# Application to AMEND a Planning Permit

Planning Permit No.: 12/0317

**RFI Request – Application No: 12/0317G**  
**40 The Esplanade, Torquay**

PROJECT TITLE:  
**PROPOSED RETAIL & RESIDENTIAL DEVELOPMENT**  
 AT:  
**40 THE ESPLANADE TORQUAY 3228**

DRAWING TITLE:  
**TOWN PLANNING  
SECTION 72 AMENDMENT**  
**SECOND FLOOR PLAN**

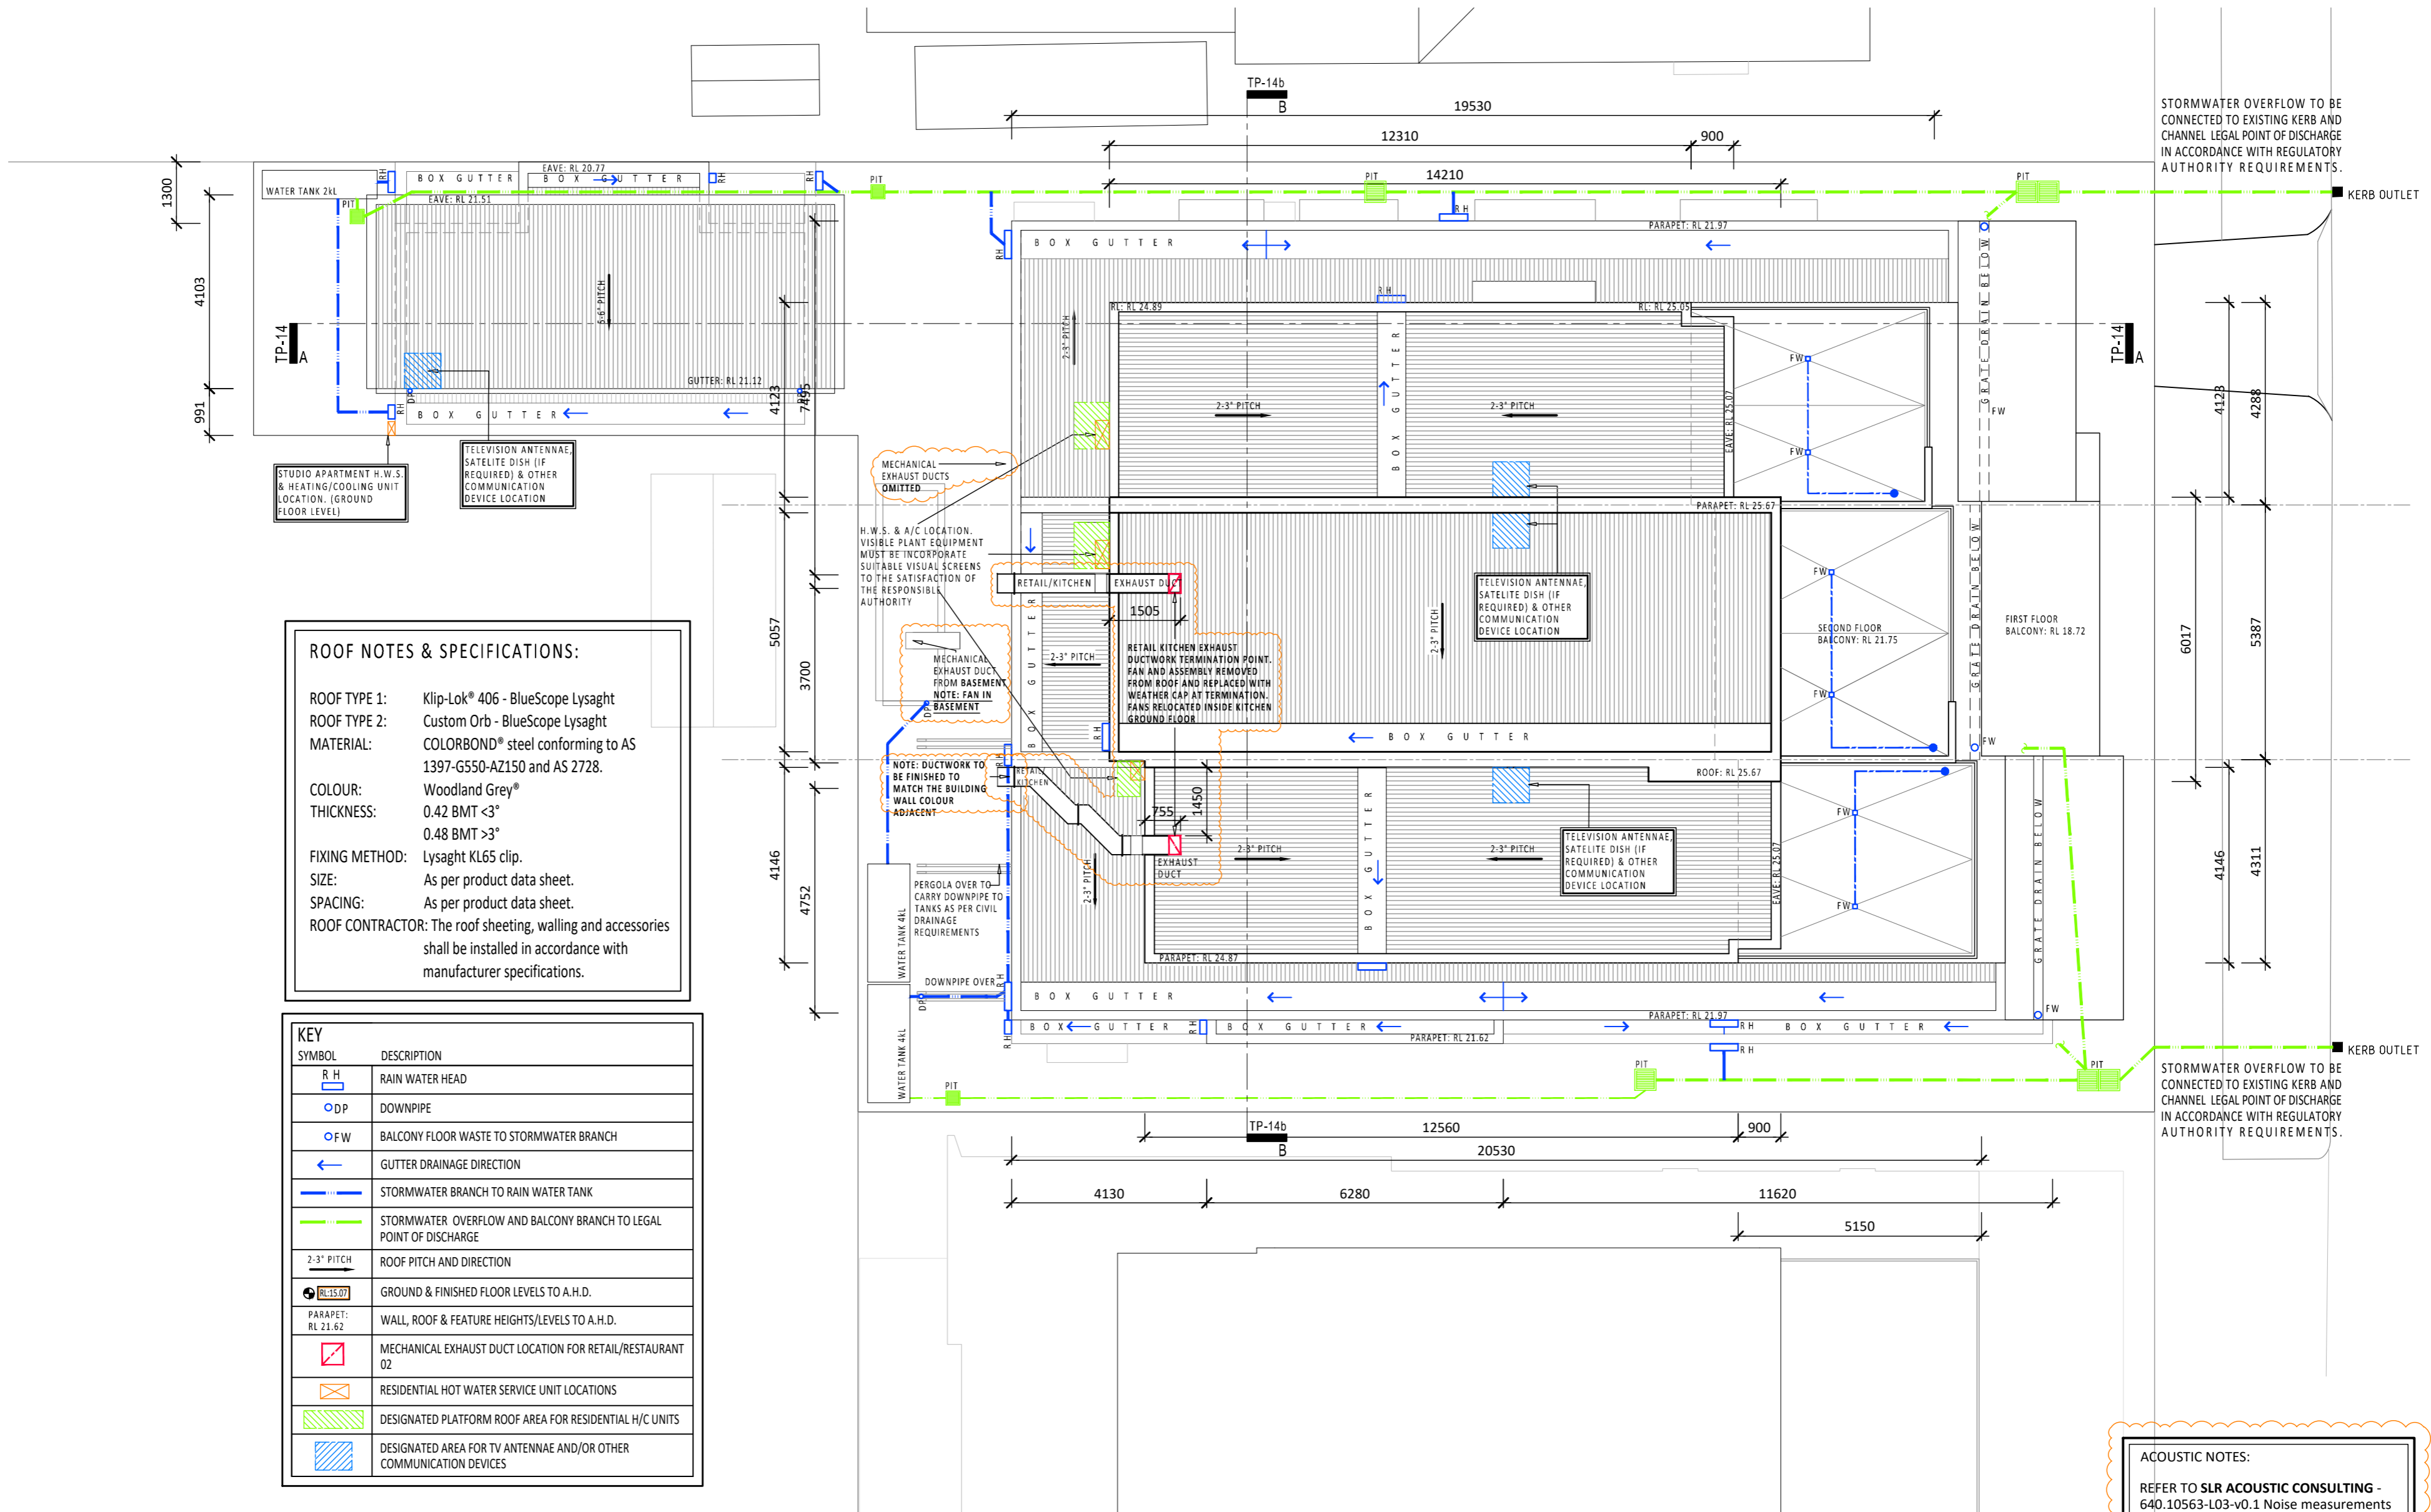
13.03.13	RETAIL AREAS REVISED. RLs NOTED.		
	ACOUSTIC REQUIREMENTS NOTED	A	NC
18.01.17	SECTION 57A	C	NC
27.04.17	SECTION 72. FAN REMOVED FROM ROOF	D	NC
18.07.17	SOUTHERN DUCT POSITION CORRECTED		
	FOLLOWING SITE INVESTIGATION, A/C		
	UNITS RELOCATED, DUCT COLOUR		
	SPECIFIED. ACOUSTIC NOTES UPDATED	E	NC
DATE:	REVISION:	No.	BY:

ISSUE DATE: 18.07.17	DRAWING REF. SK13.1_REV E	DESIGNED: NC	DRAWING No. TP-11
SCALE: 1:100 @ A2	JOB REF. 1624TORQU	DRAWN: NC	REVISION: E

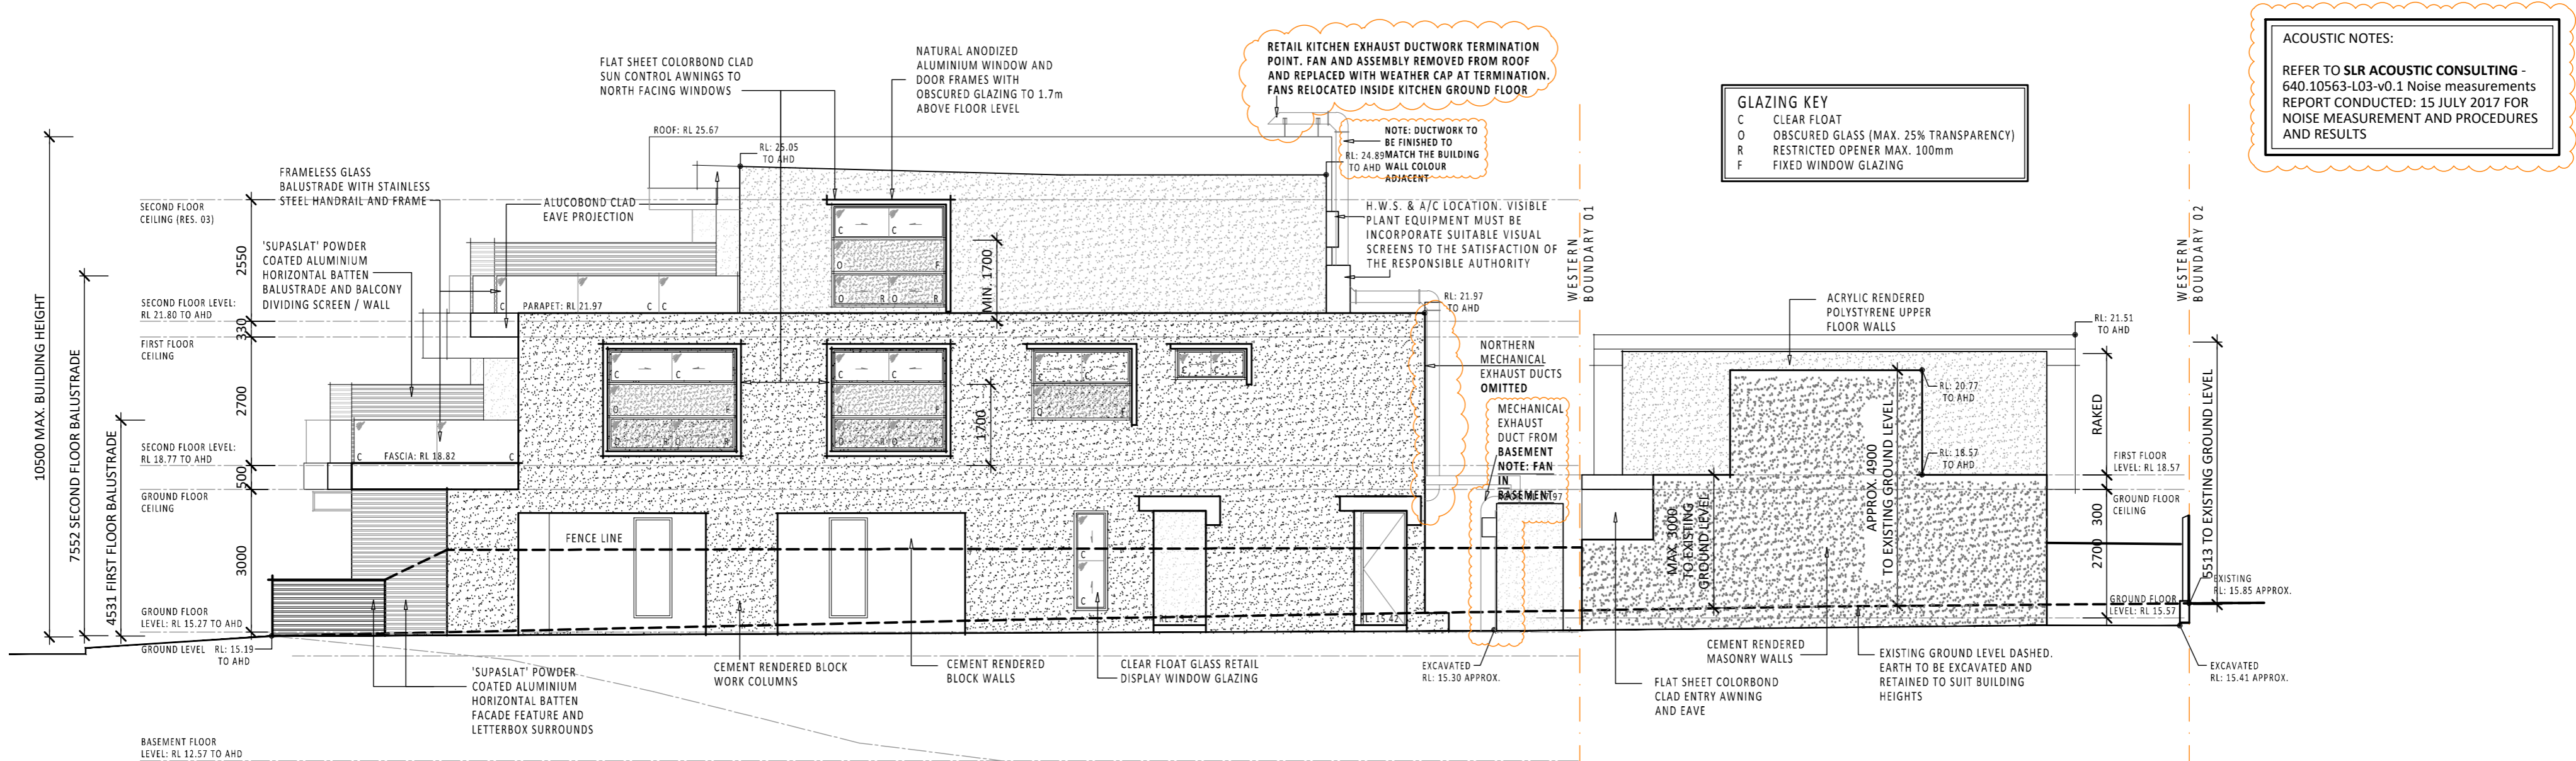
ROOF TYPE 1: Klip-Lok® 406 - BlueScope Lysaght  
 ROOF TYPE 2: Custom Orb - BlueScope Lysaght  
 MATERIAL: COLORBOND® steel conforming to AS 1397-G550-AZ150 and AS 2728.  
 COLOUR: Woodland Grey®  
 THICKNESS: 0.42 BMT <3°  
 0.48 BMT >3°  
 FIXING METHOD: Lysaght KL65 clip.  
 SIZE: As per product data sheet.  
 SPACING: As per product data sheet.  
 ROOF CONTRACTOR: The roof sheeting, walling and accessories shall be installed in accordance with manufacturer specifications.

13.01.13	RETAIL AREAS REVISED. RLs NOTED.		
18.01.17	ACOUSTIC REQUIREMENTS NOTED	A	NC
27.04.17	SECTION 57A	C	NC
18.07.17	SECTION 72. FAN REMOVED FROM ROOF	D	NC
	SOUTHERN DUCT POSITION CORRECTED		
	FOLLOWING SITE INVESTIGATION, A/C UNITS RELOCATED, DUCT COLOUR SPECIFIED, ACOUSTIC NOTES UPDATED	E	NC
DATE:	REVISION:	No.	BY:
